Site Investigation Report

Volume 2

161st AIR REFUELING GROUP
ARIZONA AIR NATIONAL GUARD
SKY HARBOR INTERNATIONAL AIRPORT
PHOENIX, ARIZONA

FINAL
SITE INVESTIGATION REPORT
161ST AIR REFUELING GROUP
ARIZONA AIR NATIONAL GUARD
SKY HARBOR INTERNATIONAL AIRPORT
AND PAPAGO MILITARY RESERVATION
PHOENIX, ARIZONA

By SWS Date 11 DEC 90 Subject SKETCH MAP OF AREA AROUND Sheet No 1 of
Chkd By Date SITE NO 3 ADAPTED FROM BASE ENG. DRAWING Proj. No 409321

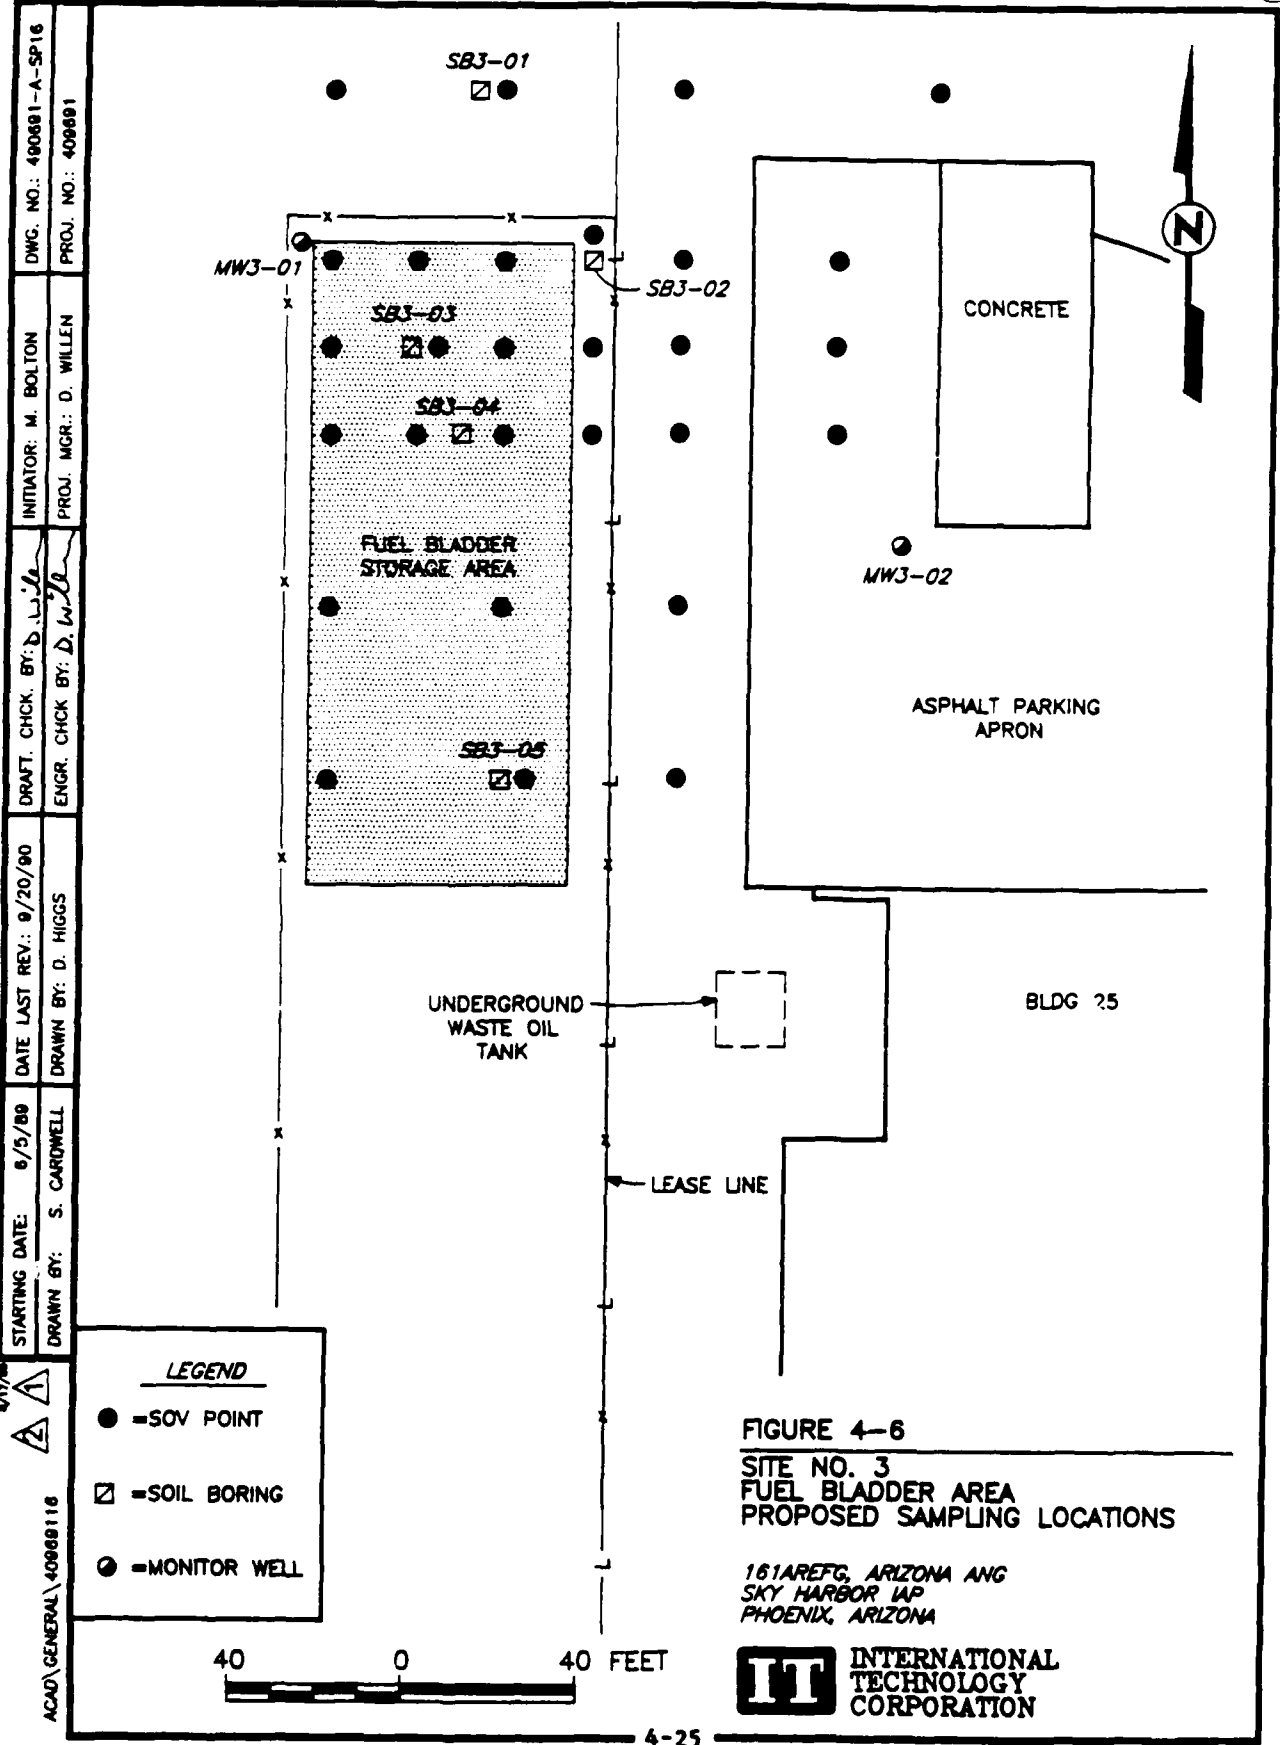
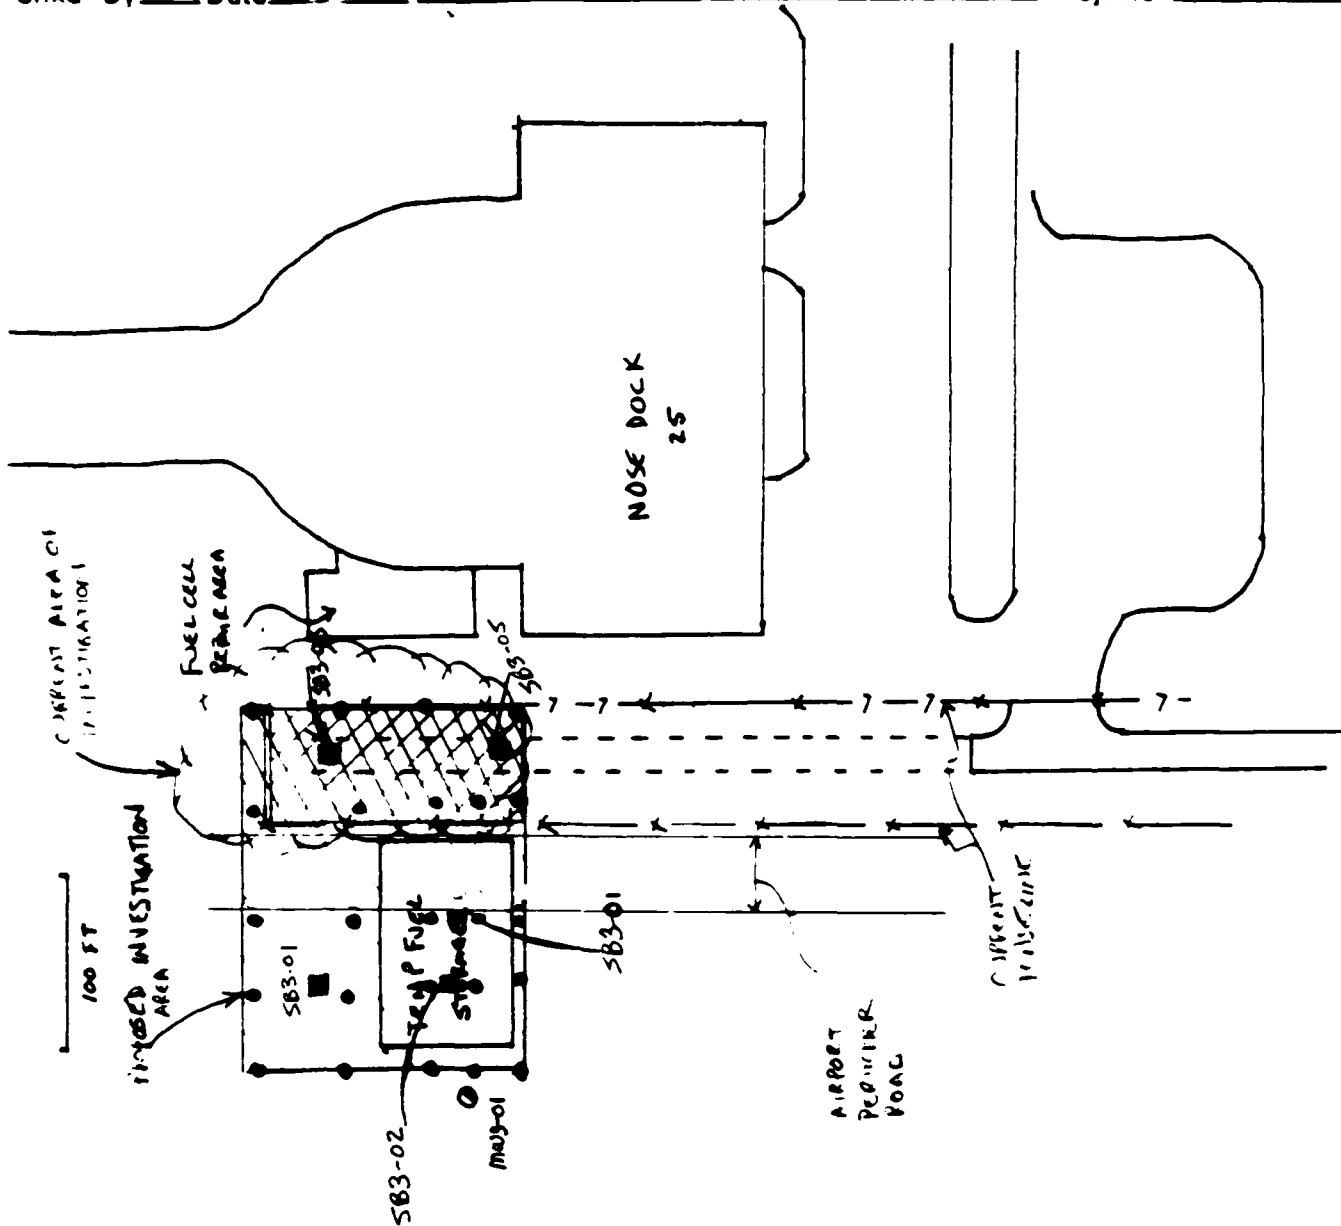
THE FIELD SAMPLING PLAN WAS PREPARED UTILIZING EXISTING BLUE LINE DRAWINGS FROM THE BASE. IN PARTICULAR, SITE 3 WAS A FUEL STORAGE AREA BELIEVED TO HAVE BEEN WITHIN A CYCLONE FENCED AREA (ATTACHMENT 1). RECENT UTILITY CLEARANCE ACTIVITIES DISCLOSED A 1972 MAP SHOWING THE FUEL STORAGE AREA ADJ. 150 FT. WEST OF LEASE LINE. THE PURPOSE OF THIS VARIANCE IS TO REQUEST MODIFICATION OF SAMPLING AREAS TO THOSE SHOWN ON ATTACHMENT 2. NO SCOPE CHANGE IS ENVISIONED. THE SAME SAMPLING POINTS OCCUR BUT IN SLIGHTLY DIFFERENT LOCATION TO ADEQUATELY CHARACTERIZE THE SITE.
